PD Modification Application: PRS 26-0005**Zoning Hearing Master Date:** N/A**BOCC Land Use Meeting Date:** December 9, 2025**Hillsborough
County Florida**

1.0 APPLICATION SUMMARY**Applicant:** Lifestyle Communities, LTD**FLU Category:** UMU-20**Service Area:** Urban**Site Acreage:** 137 +/-**Community Plan Area:** Apollo Beach & South Shore
Areawide Systems**Overlay:** None**Introduction Summary:**

The applicant requests modifications to PD 86-0154 (PRS 25-0104) Tract 1 (located in the northeastern portion of the PD) as noted below. The proposed modifications do not alter the approved density or intensity entitlements.

PD Inset Map for Development Areas – Proposed PRS

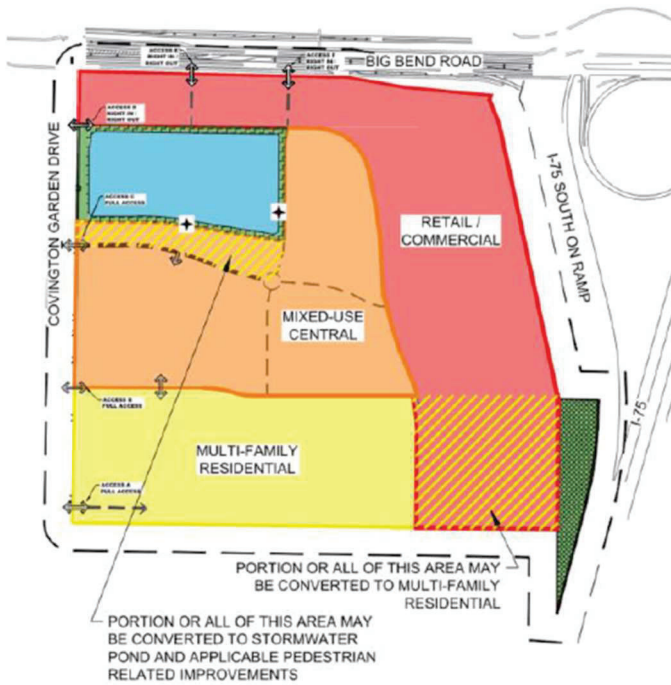
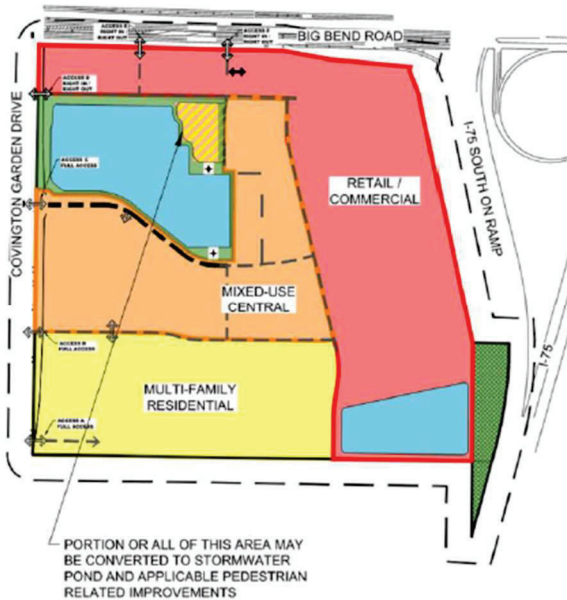
Tract 1 Development Summary as shown in the conditions of approval	Update Tract 1 Development Summary to reflect development area changes
One stormwater pond in the northwest corner of Tract 1.	Two stormwater ponds, one in the northwest corner of Tract 1 and one in the southeast corner of Tract 1

8.2 Proposed Site Plan (Full)

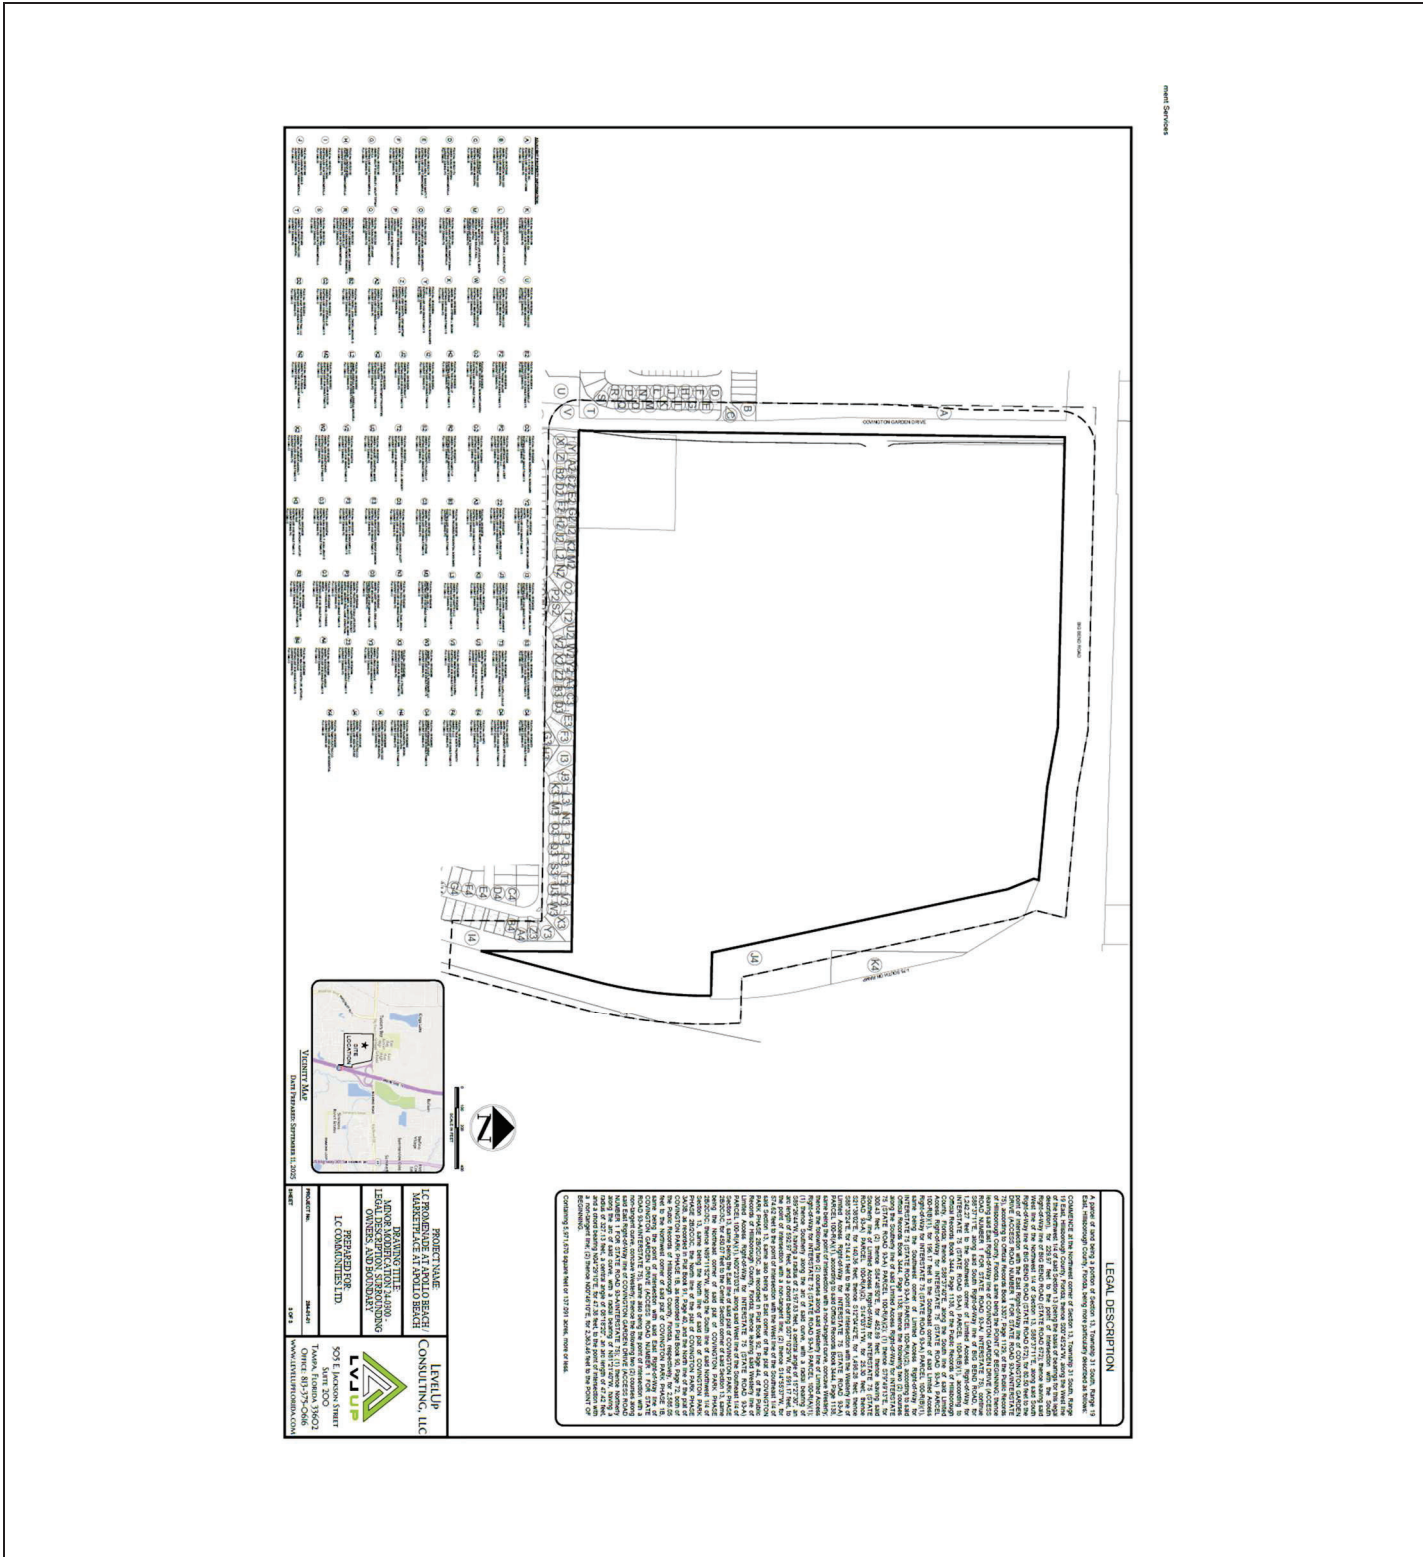
The proposed site plan changes include a stormwater pond in the southeastern portion of the site, which at its narrowest span of 263 feet is in conjunction with an additional 30-foot buffer with enhanced Type “B” screening. The currently permitted CG zoning district uses are permitted a minimum setback of 65 feet from the southern boundary. The stormwater pond would increase the separation of proposed CI zoning district uses from the single-family development to the south from 65 feet to at least 293 feet.

[The applicant is proposing to remove the potential internal roundabout shown on the PD site plan. The visual reference of the roundabout acted as a visual indicator on the PD site plan and anchor for this and certain other conditions. Transportation Review Section staff is proposing changes so that the conditions will continue to be operable (and make sense) given removal of the roundabout. In order to do this, staff is also defining a new segment (Segment J) to aid in condition description. Unfortunately, given the timing of filing deadlines it wasn't possible to have the applicant add this to the PD site plan and no "prior to certification" process is available for PRS applications. Lastly, staff discussed with the applicant's transportation engineer that the original conditions had apparently omitted the intent of the entry boulevard (i.e. defining that segment as the 3-lane section as necessary to act as receiving lanes for the dual southbound to eastbound left turn lanes on Covington Garden Dr. into the site and which are necessary to efficiently circulate traffic through the site), and so staff is proposing that clarification as well.]

[Except as otherwise shown on the PD site plan, No](#) connection shall be located within 245 feet of the ~~roundabout~~ [intersection of Segment J and Segment C.](#)
